U.S. Department  
of Transportation  
**Federal Highway  
Administration**

March 29, 2011

In Reply Refer To:  
HSST/B-218

Name of system: F-Shape Reinforced Concrete Barrier with Slotted Drain Holes  
Type of system: Permanent F-Shape Reinforced Concrete Barrier  
Test Level: National Cooperative Highway Research Program (NCHRP) Report 350  
Test Level 4 (TL-4)  
Testing conducted by: Texas Transportation Institute (TTI)  
Date of Request: December 9, 2010  
Drawing Designator: SBC04d

**CAST-IN-PLACE BARRIER RAILING TRANSITION (TRANSITION ON WINGWALL)**

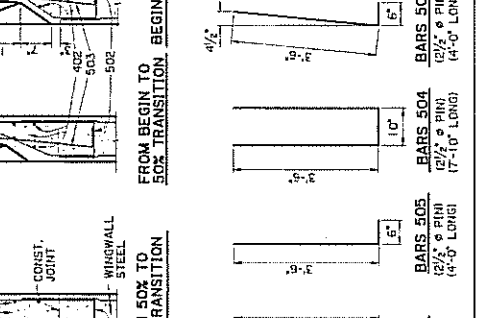
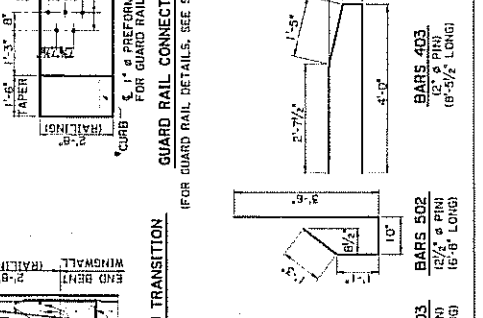
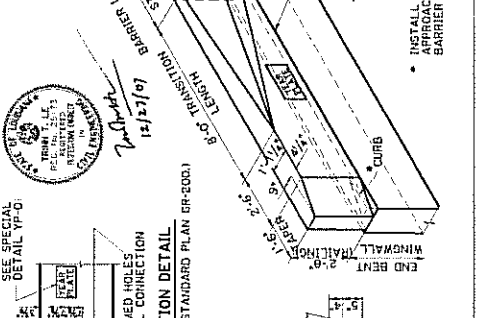
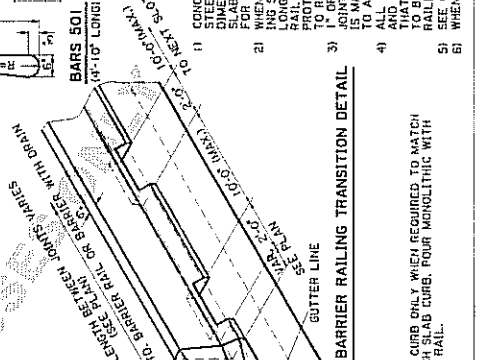
The Louisiana Department of Transportation and Development (La DOTD) currently uses a cast-in-place concrete bridge rail on Louisiana bridges. The F-Shape bridge rail is 32 inches in height and 13.25 inches wide at the base. Presently, for bridges that use this concrete F-Shape bridge rail, drainage is provided only at the ends of the bridge since there is no opening provided

through the bridge rail. La DOTD has proposed the use of 6 inches high x 24 inches long open slots located 10 feet apart at the base of the rail to accommodate drainage through the railing. Details of the proposed bridge rail are provided as enclosure to this correspondence.

Therefore, the system as described in the request above and detailed in the enclosed drawings is acceptable for use on the NHS under the range of conditions tested, when such use is acceptable to a highway agency.

Figure 76 – LaDOTD F-Shape Barrier, TXDOT Wildlife Crossing Barrier WSDOT Pin & Loop Barrier Cross-Sections

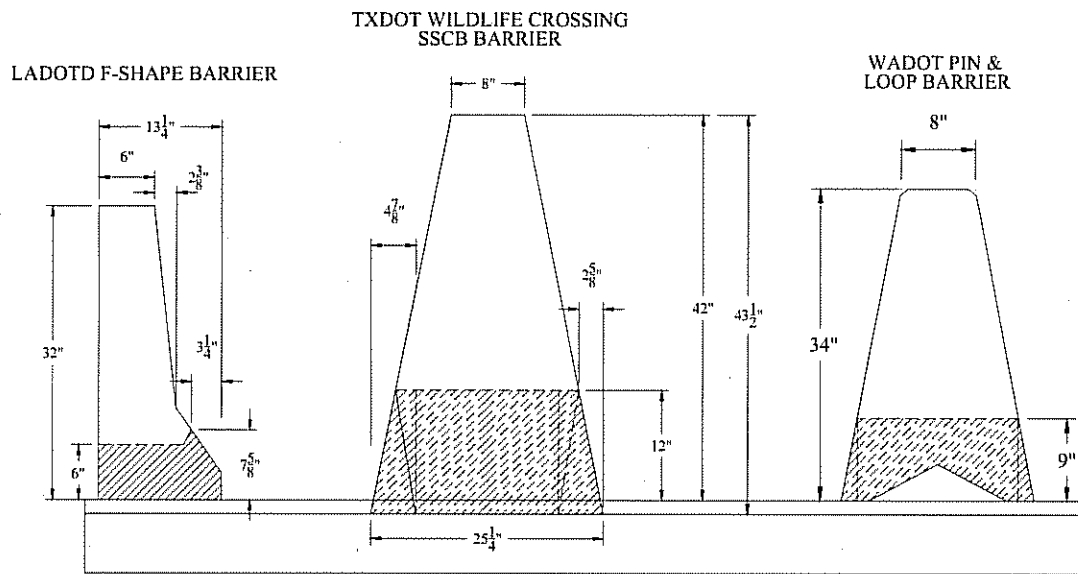
The proposed drainage slot details were compared with other barriers systems utilizing similar type slots. This review consisted of comparisons with the Texas Department of Transportation (TXDOT) Single Slope Concrete Barrier (Wildlife Crossing) Precast SSCB (TXDOT Wildlife Crossing Barrier) and the Washington Pin & Loop Barrier System designed and successfully crash tested by TTI for the Washington State Department of Transportation (acceptance letter HSSD/B-206). The TTI researchers performed a similar review of the TXDOT Wildlife Crossing Barrier for TXDOT with respect to the size and potential interaction of these openings with respect to the small car and pickup truck for the NCHRP Report 350 crashworthiness criteria.

The ratio in height of the contact length of the F-Shape Barrier to 32 inches total height of rail (i.e., rail contact width to height) is 0.762. Based on the proposed barrier geometry and the information provided in AASHTO Figure A13.1.1-3, the proposed barrier is considered marginal.

The analysis of the drainage slot used in the Washington State Department of Transportation Pin & Loop Barrier (WSDOT barrier) appeared to perform well in LS-DYNA impact simulations with both the small car and pickup truck. Although the WSDOT barrier did not meet the AASHTO Manual for Assessing Safety Hardware test specifications, the 9-inch high drainage slot specified used in the WSDOT barrier system did not adversely affect the performance of the crash vehicle. In addition, the potential for vehicle interaction with the drainage slot opening was considered low to marginal with respect to the criteria as provided in

AASHTO Section 13 specifications. Based upon the researchers' analysis, the F-Shape barrier with drainage slots is considered acceptable with respect to Report 350 TL-4 performance criteria.

Details including a side-by-side comparison between size openings of TXDOT Wildlife Crossing Barrier, WSDOT barrier, and LaDOTD F-Shape Barrier with drainage slots are provided as enclosure to this correspondence.
